# Dual-signature MPS state diagram v132

### 33.2.5.12 Type 3 and Type 4 state diagrams

Figure 33–22 — Type 3 and Type 4 PSE MPS monitor state diagram for single-signature PDs or 2-pair operation

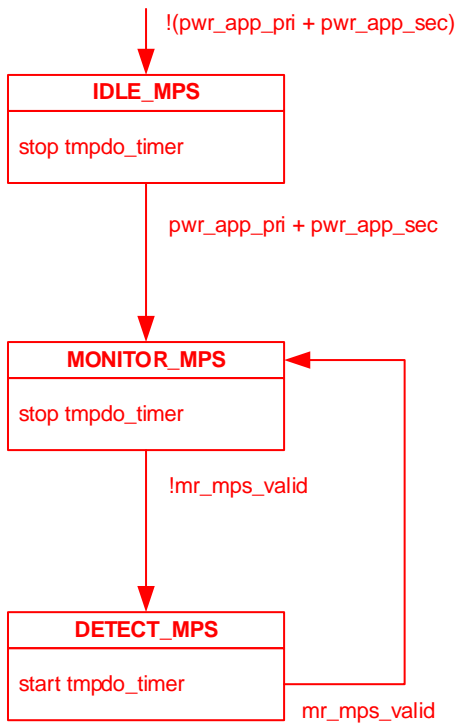
The Type 3/Type 4 state diagram depends on `tmpdo_timer_pri` and `_sec` for dual-signature MPS operation, but these timers are never started or stopped. The state diagram duplicates the logic described in 33.2.10.1.2, there is no need for this. Both implementation options (monitoring the pairset with the highest current, or monitoring the total amount of current of both pairsets) are supported by `mr_mps_valid`.

The state machine now only handles the timing aspect of MPS. Whether or not MPS is absent or present is handled by 33.2.10.1.2.

Replace Figure 33–22 as follows:

Figure 33–23 — Type 3 and Type 4 PSE MPS monitor state diagram for dual-signature PDs

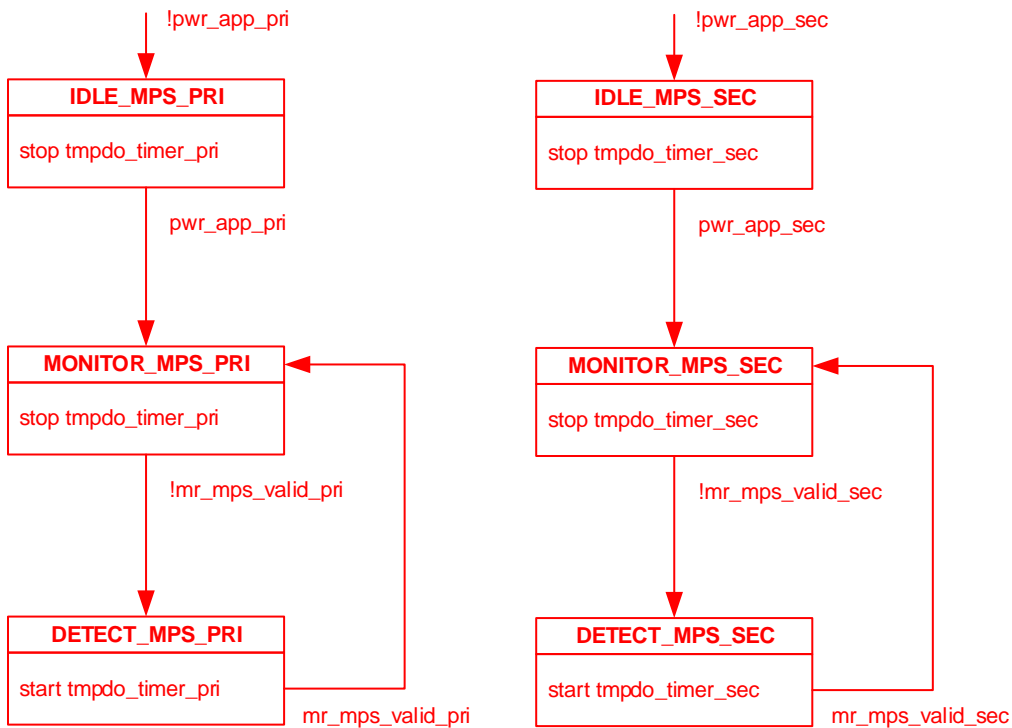
Insert new Figure after Figure 33–22 as follows:
